CITY OF GLENDALE, CA

DESIGN REVIEW STAFF REPORT – MULTI-FAMILY / MIXED USE

June 14, 2021	426 Ivy Street
<i>Decision Date</i>	<i>Address</i>
Administrative Design Review (ADR)	5695-007-009
<i>Review Type</i>	<i>APN</i>
PDR2105036	Haykanush Ananyan
<i>Case Number</i>	<i>Applicant</i>
Danny Manassarian	Suren Zakaryan
<i>Case Planner</i>	<i>Owner</i>

The applicant is proposing to demolish an existing 1,984 SF two-story, single family house (built in 1910) and construct a new four-unit, multi-family residential building on a 6,250 SF lot in the R-1250 (High Density Residential) Zone, located at 426 Ivy Street.

1 PARKING LEVEL FLOOR PLAN
1/4" = 1'-0" 0' 4' 8' 16'

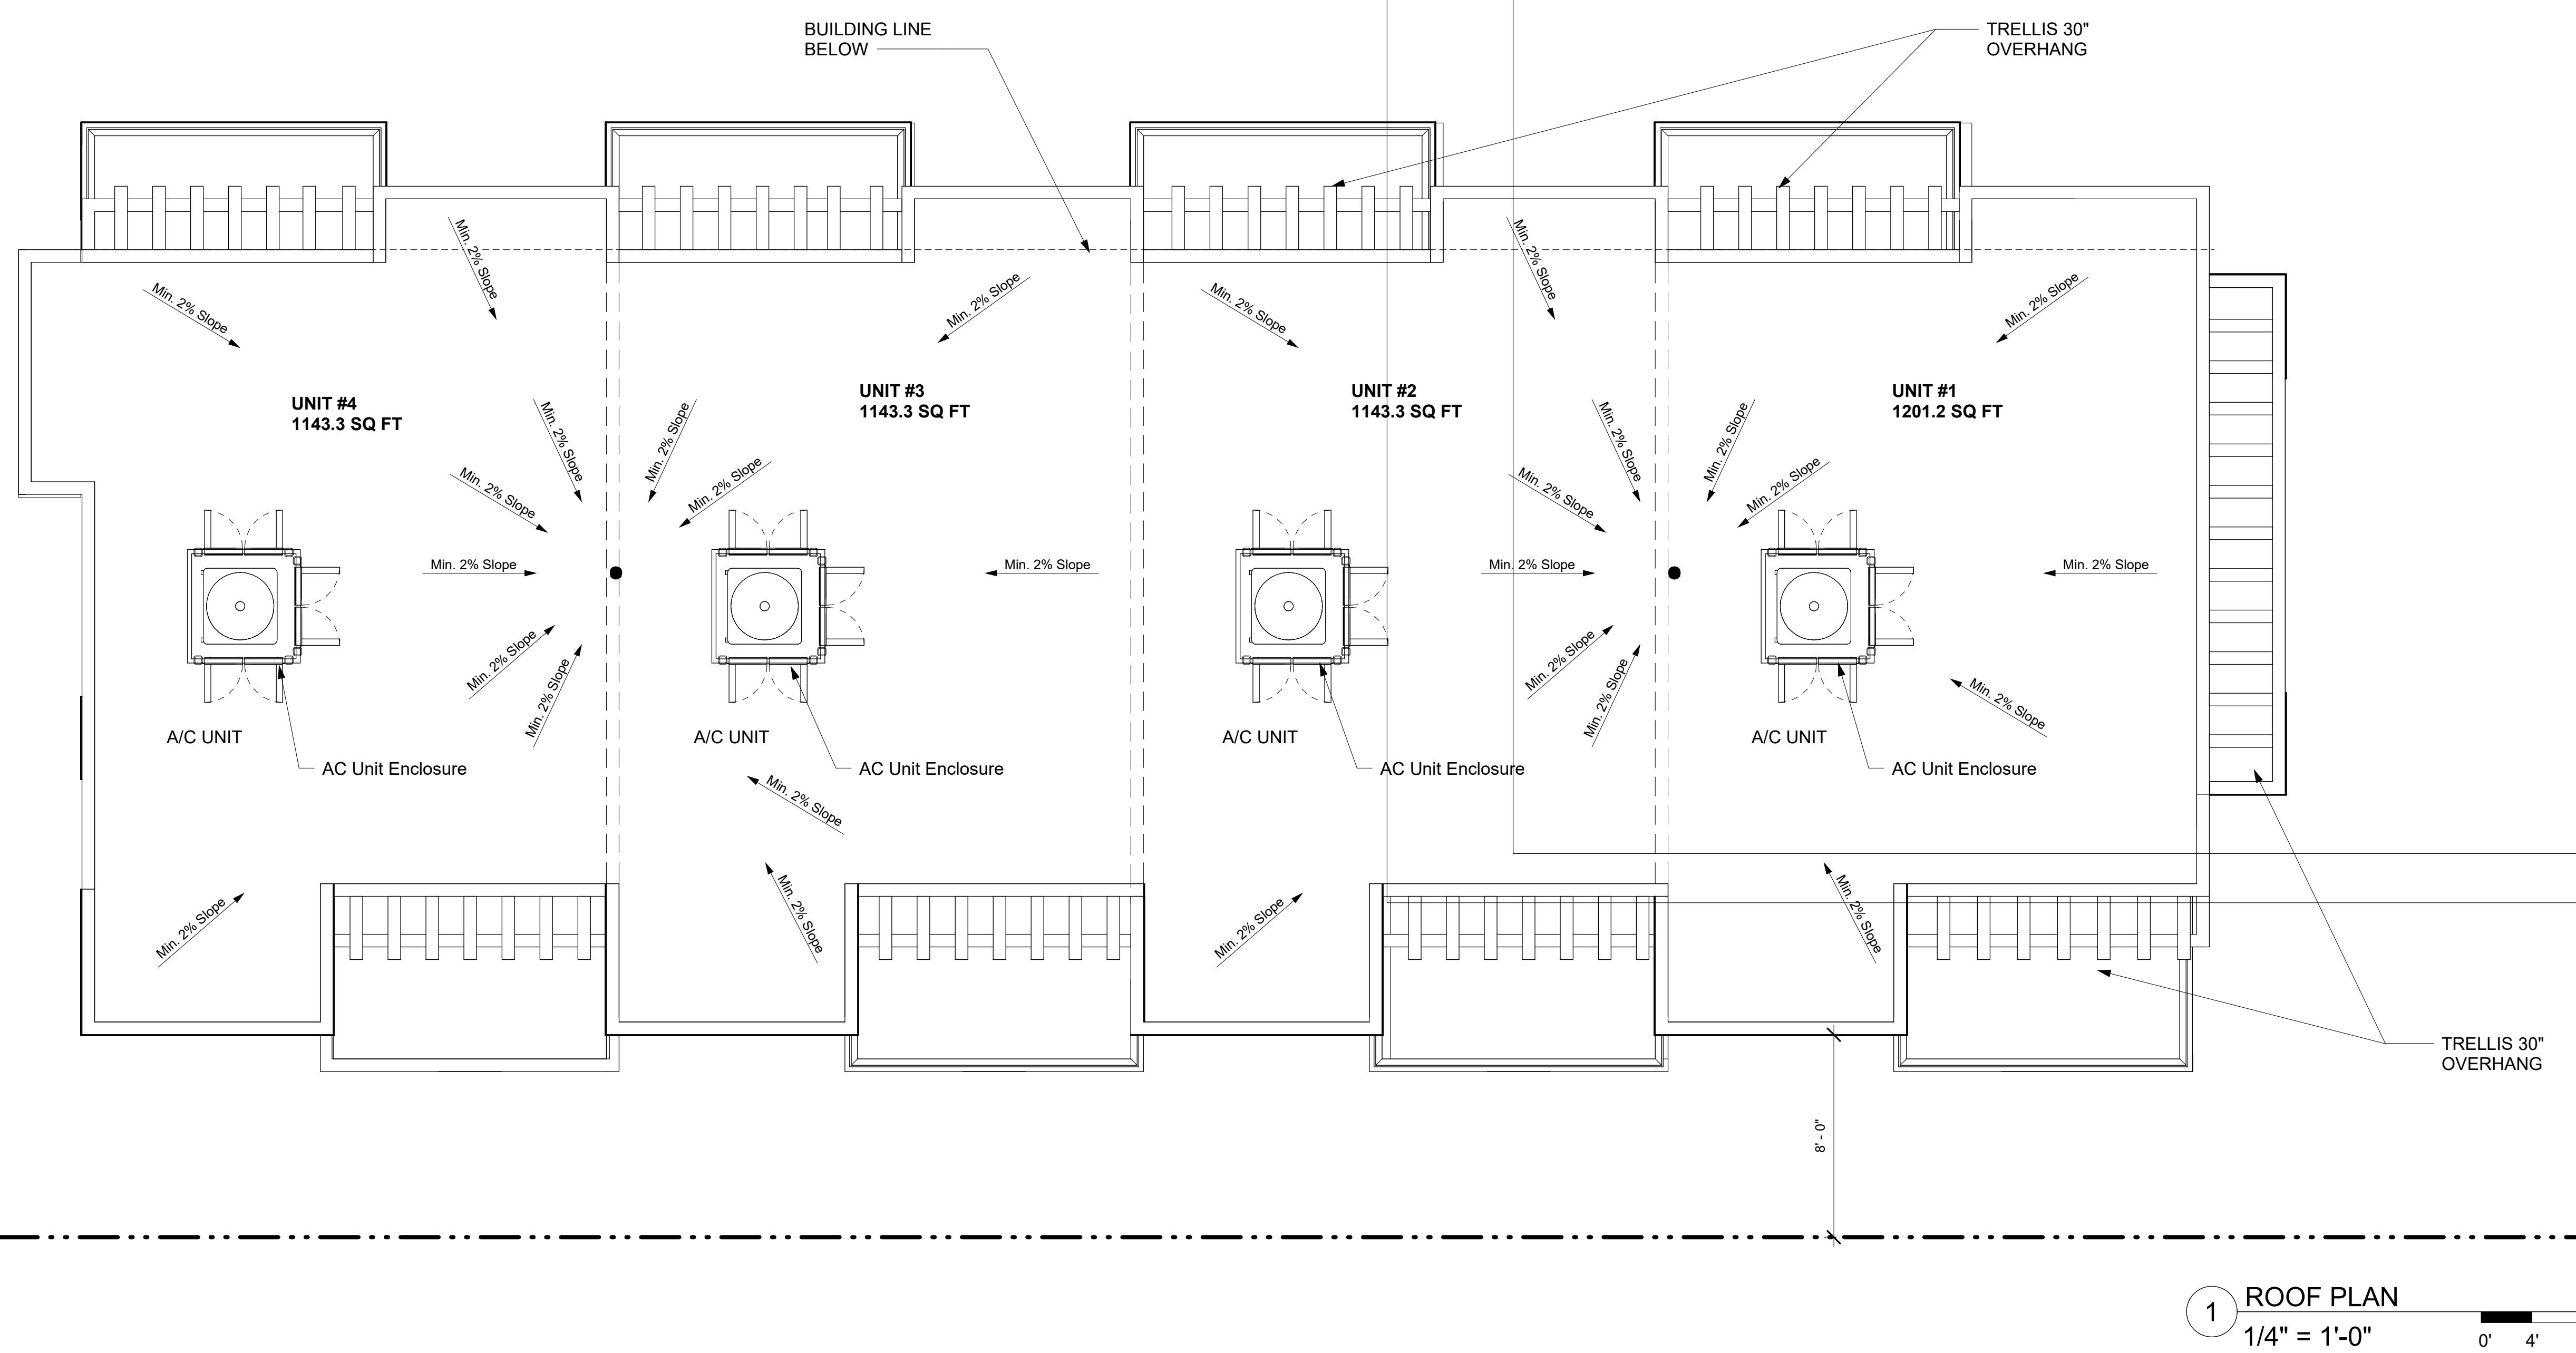
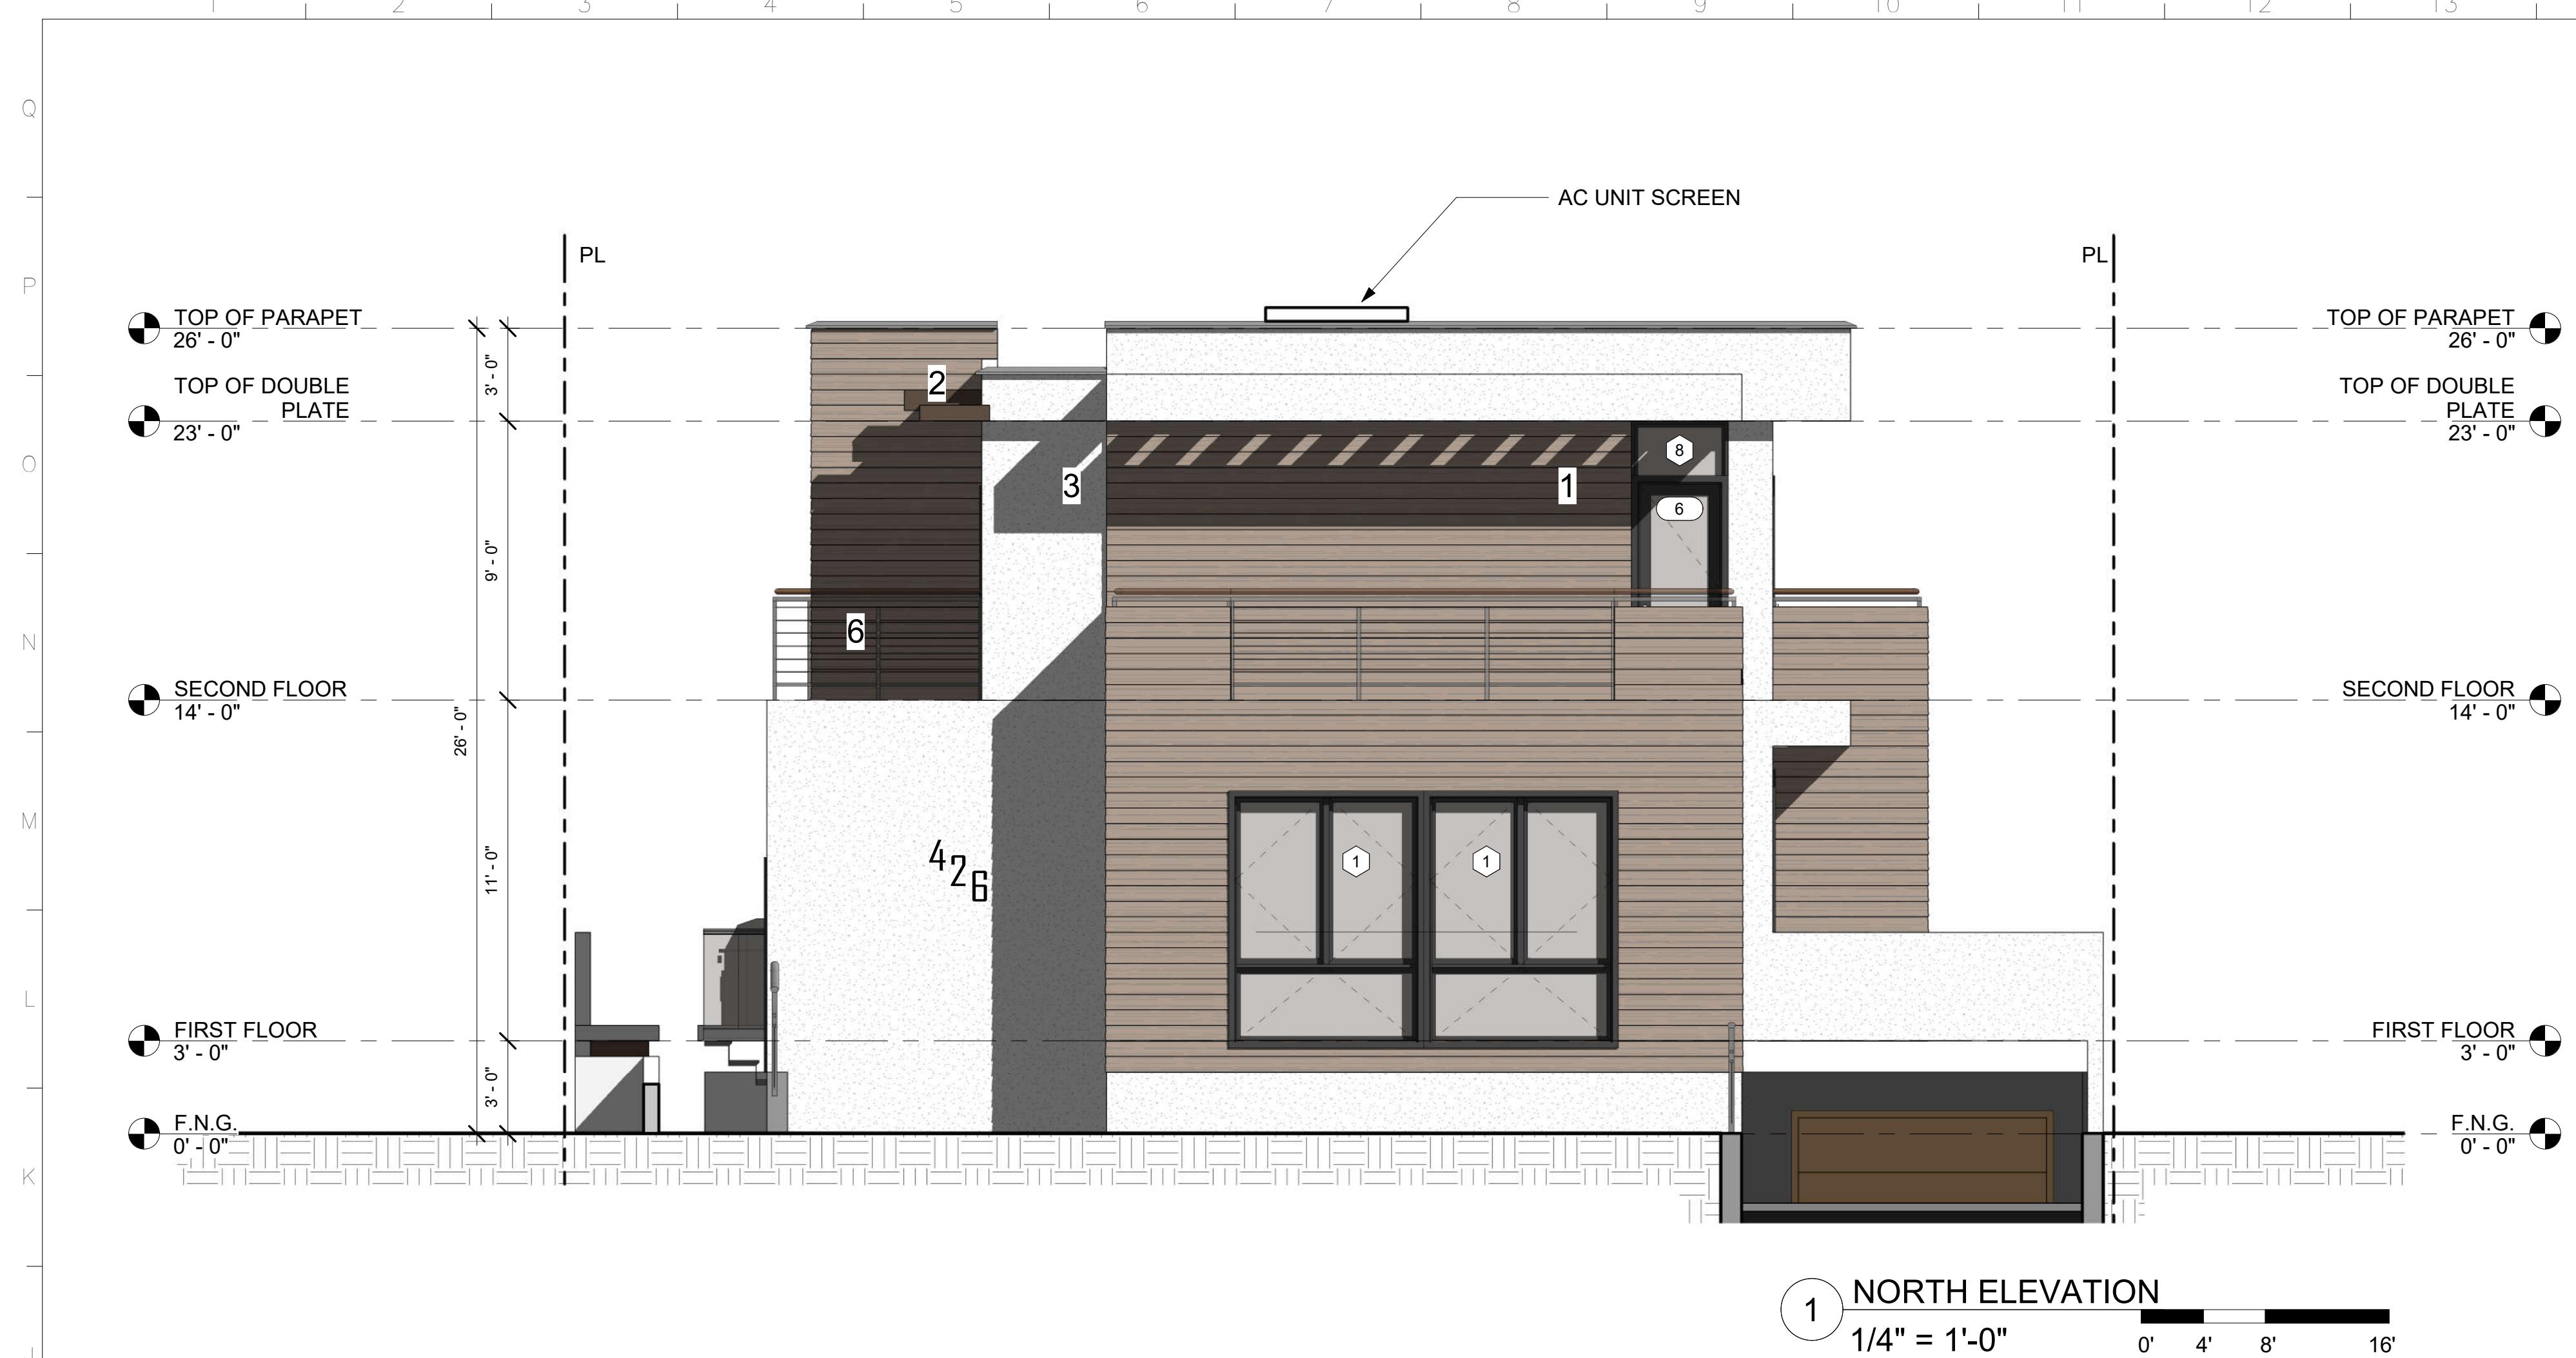
Window details are missing from plans. Applicant shall revise window schedule to show the material, frame type, and sill and frame detail for staff review.

- All new windows will be a combination of casement (only at the front façade), fixed, and slider operations. The proposed fenestration is compatible with the modern style of the building. A condition of approval has been added to revise the window schedule to show the material, frame type, and sill and frame detail for staff review.

1. New landscaping to be drought tolerant.
2. Revise window schedule to show the material, frame type, and sill and frame detail for staff review.
